Access Compliance Report

Public Rights-of-Way

Intersection ID: 53912	Main Street: BRITTONDALE LN	Cross Street: PINYON_PINE LN	Location: SW
ADA ID: FF48094D7609	Ramp Type: BlendTrans1	Initial Pass/Fail: Fail	Overall Compliance: No
Severity Score: 8.75			
Codes/Mitigation Info/Possible Solution		Field Measurements/Component Compliance

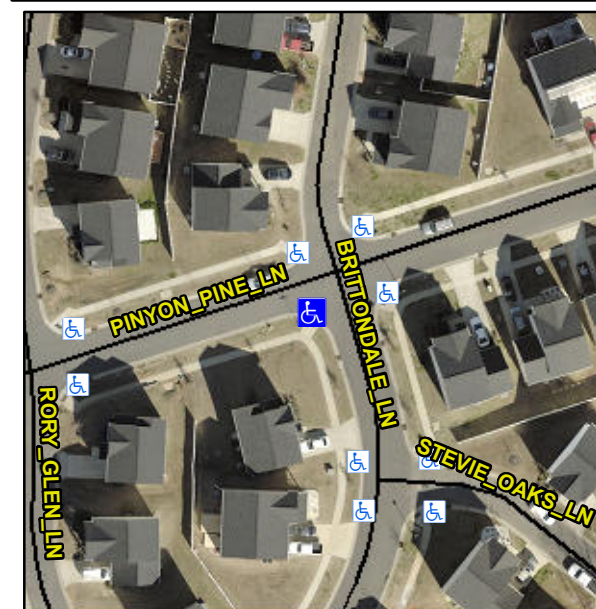
Not Found, R304.5.1

Compliance	Description	Data	Compliance	Description	Data
N/A	Ramp Length (in)	91.5	Yes	BlendTrans Slope (%)	4.9
No	Ramp Width (in)	47.5	Yes	BlendTrans XSlope (%)	1.5
N/A	Flare Type LT	N/A	N/A	Flare Type RT	N/A
N/A	Flare Slope LT (%)	N/A	N/A	Flare Slope RT (%)	N/A
N/A	Flare Traversable LT?	N/A	N/A	Flare Traversable RT?	N/A
N/A	Landing Length (in)	N/A	N/A	DWS Provided?	N/A
N/A	Landing Width (in)	N/A	N/A	DWS Contrast?	N/A
N/A	Landing Slope (%)	N/A	N/A	DWS Length (in)	N/A
N/A	Landing X Slope (%)	N/A	N/A	DWS Full Width?	N/A
N/A	Landing Curb? (Y/N)	N/A	N/A	DWS Offset (in)	N/A
N/A	Shared Landing?	N/A			
N/A	Gutter Ponding?	N/A	N/A	Gutter Slope (%)	N/A
N/A	Gutter Lip Ht (in)	N/A	N/A	Gutter X Slope (%)	N/A
N/A	Painted X Walk1?	No	N/A	Painted X Walk2?	No
	X Walk 1 Direction	To E		X Walk 2 Direction	To N
	X Walk 1 Width (in)	N/A		X Walk 2 Width (in)	N/A
	X Walk 1 Slope (%)	0.5		X Walk 2 Slope (%)	2.6
	X Walk 1 X Slope (%)	2.7		X Walk 2 X Slope (%)	1.2

N/A	Ramp inside XWalk1?	N/A	N/A	Ramp inside XWalk2?	N/A
	Road Slope (%)	1.2		Clear Space?	N/A
	Road X Slope (%)	2.2	N/A	Clear Space to XWalk (in)	N/A
N/A	Any Obstructions?	N/A	N/A	Storm Grate/Utility Hazard?	N/A
	Obstruction Type			Storm Grate/Utility Type	
		N/A			N/A
			Yes	Surface Condition? (G/P)	Good
			No	Curb Slope (%)	14.7

Remove & Replace Curb Ramp With Two New Directional Ramps or Equivalent.
